SUBDIVISION COMMITTEE  
METROPOLITAN AREA PLANNING COMMISSION

STAFF REPORT

CASE NUMBER: S/D 91-24 - ARLINGTON LAKES ADDITION

STAFF REPORT  
(Preliminary Plat)

VICINITY MAP:

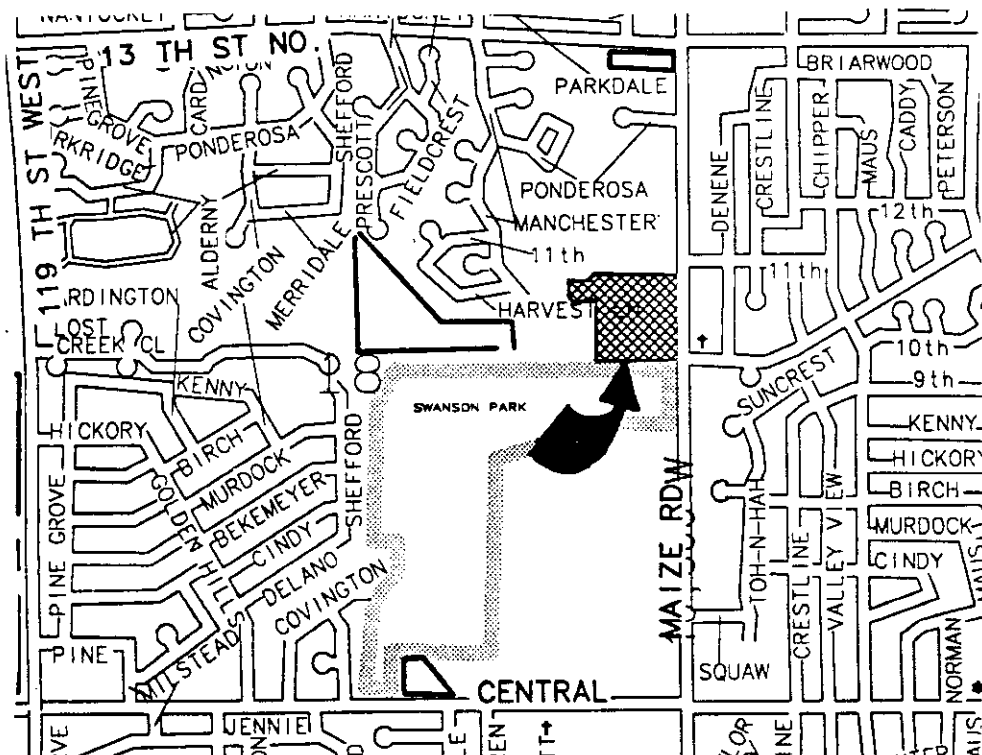
- A. The applicant shall guarantee the extension of sanitary sewer to serve the lots being platted.
- B. The applicant shall guarantee the extension of City water to serve the lots being platted.

- C. The applicant shall guarantee any drainage improvements required by the platting of this property.
- D. The applicant shall guarantee construction of the storm sewers required by this plat.

- E. The applicant shall guarantee the paving of the proposed interior streets. Upon the recording of this plat, Harvest Lane shall become a designated residential collector street. As a collector, sidewalk is also required along Harvest Lane. Based on existing sidewalks along this street or as guaranteed by other plats, a sidewalk shall be guaranteed along the south side of Harvest Lane and may be included within the paving petitions.

- F. As indicated in the C.U.P., at the time of platting the need for a decel lane along Maize Road is to be determined. Harvest Lane is the only entrance off of Maize Road into much of the development existing or planned in the quarter section covered by the C.U.P. Prior to submitting the final plat, the applicant was to meet with City Engineering to determine how or when this improvement is to be provided and as to the guarantee that may be required. City or Traffic Engineering, therefore, needs to indicate what requirements need to be provided at this time.

- H. City Engineering needs to indicate if the temporary turnaround for Harvest Lane is acceptable. If it is acceptable, the right-of-way shall be dedicated by separate instrument. It shall be indicated that upon the extension of Harvest Lane to the west or other satisfactory access, that the dedication will automatically be vacated. This document shall be submitted to City Engineering for approval and to Planning for recording with the plat.

- L. The final plat tracing shall indicate the utility easements requested by K.G. & E. and Southwestern Bell.
- M. Since fences, landscaping, or similar type obstructions can typically be placed within easements, it shall be clearly indicated in the plat's text that no fences or other obstructions can be placed within the "access easement" located on Lot 10, Block 1.

- O. On the final plat tracing, the spelling of the word "landscape" shall be corrected on the face of the plat, by the Maize Road and Harvest Lane intersection.

VICINITY MAP:

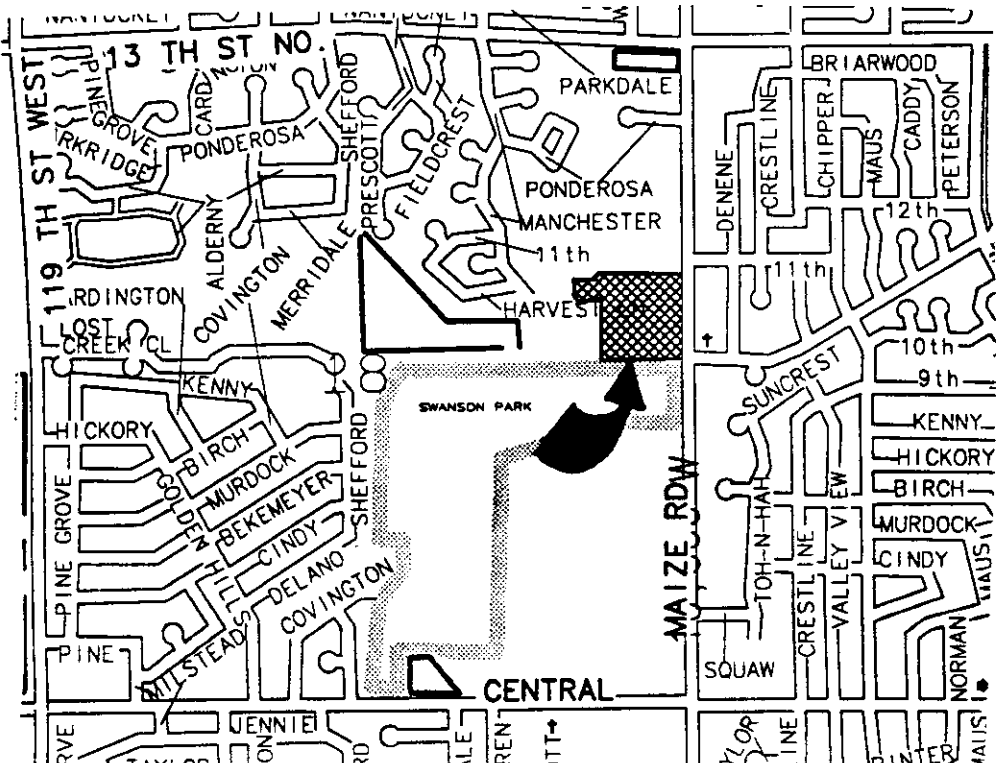
- A. Prior to this plat being forwarded to the City Council, the applicant shall meet with Planning department staff to determine if the C.U.P. needs to be adjusted or amended to reflect the intended change in the use and ownership of the areas corresponding to parcel 14 of DP-152. The applicant shall also submit a letter or letters from any homeowner's association within the area of DP-152 indicating that they have no objection to these changes.

- G. As indicated in the C.U.P., at the time of platting the need for a decel lane along Maize Road is to be determined. Harvest Lane is the only entrance off of Maize Road into much of the development existing or planned in the quarter section covered by the C.U.P. Traffic Engineering should be prepared to indicate if a decel lane or other traffic improvements need to be guaranteed for this site.

- I. While this plat is proposing to alter a portion of the area shown for open space in the C.U.P. as parcel 14, a larger area to the north and west of this plat is shown as being open space. A lake also presently exists in this area. On the C.U.P., the area which basically corresponds to lot 10, Block 1 was intended to be a portion of a reserve allowing for access to that lake and open space area. Further, this access strip would also allow for a connection to a Reserve south of Harvest Lane that eventually gives access to the City's Swanson Park to the south of this site. This plat, however, indicates the loss of access to both the Swanson Park site and the open space indicated by the C.U.P. The final plat should either be redesigned to allow for the access as depicted in the C.U.P. or the required adjustment or amendment to the C.U.P. should also address the changes being reflected by this plat.

- M. If utilities are to be confined to an easement in Reserve "D", the final plat shall show an easement in this reserve, or the plattor's text shall simply indicate that the reserve's uses include utilities.

- N. To better locate the easement across the central portions of lots in block 1, the final plat shall provide additional dimensions from lot corners to this easement.

- O. Prior to or at the time of submitting the final plat, the applicant shall submit a drainage plan to City Engineering for review and approval.
